### **REMARKS**

The instant application is directed to a method of manufacturing a distributed analog phase shifter, the method comprising, depositing a ferroelectric film on a substrate, etching the ferroelectric film to form ferroelectric patterns, depositing a metal layer on the substrate on which the ferroelectric patterns are formed; and forming a coplanar waveguide, first electrodes, a ground line, and second electrodes by etching the metal layer covering the ferroelectric patterns, wherein the first electrodes and the second electrodes are formed such that portions of the first electrodes and second electrodes overlap with the ferroelectric pattern, respectively.

#### **II. Drawing Objection**

FIG. 4A

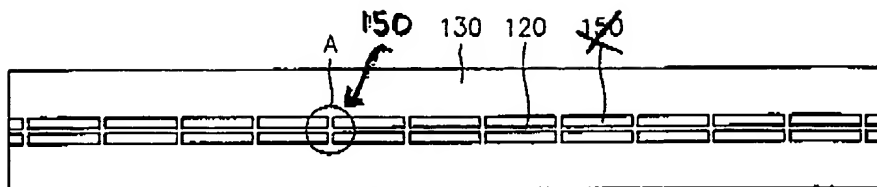
In the outstanding Action, the Examiner objects to the drawings for failing to comply with 37 CFR 1.84(p)(4) alleging reference character "150" is used to designate the indigitated capacitor ("IDC") shown in Figure 4C whereas in Figure 4A "150" does not point to the IDC of Figure 4C. The Examiner further alleges in Figure 4A, the reference number "150" points to a region outside of Figure 4B. Applicants respectfully submit herewith corrected drawing sheets in compliance with 37 CFR 1.121(d) and marked up drawings in which reference number "150" has

been corrected to refer to the correct grouping of components. In view of the foregoing, Applicants respectfully request reconsideration and withdrawal of the objection to the drawings on this basis.
